Customer Service Bulletin Commercial Business Group

Workman[®] 3000/4000 Series

Subject: Rear Wheels May Loosen.

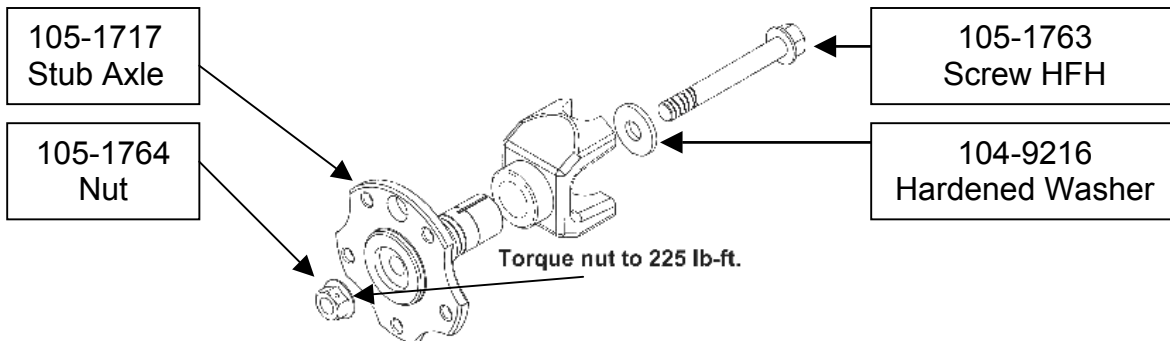
Some rear wheels have been found to loosen at the Stub Axle (93-7090-03). The Flange Lock Nuts (32128-53) can become loose through normal operation of the vehicle. This condition can allow the Stub Axle and wheel assembly to come loose from the End Yoke (92-4190) of the Driveshaft Assembly (98-2918).

The parts noted below are now available to improve the retention of the assembly.

Stub Axle	105-1717
Screw- HFH	105-1763
Nut	105-1764
Hardened Washer	104-9216.

When installing these parts, torque the bolt/nut assembly to 225 ft.lbs (305 Nm)* with the Nut located on the wheel side of the Stub Axle assembly. This improved Stub Axle Assembly is currently available through your local Toro Commercial Products Distributor, one of each part specified is required per rear wheel on the 3000/4000 Series Workman vehicle.

* Caution: Many air impact wrenches do not exceed 100 ft.lbs.(136 Nm) torque capacity.
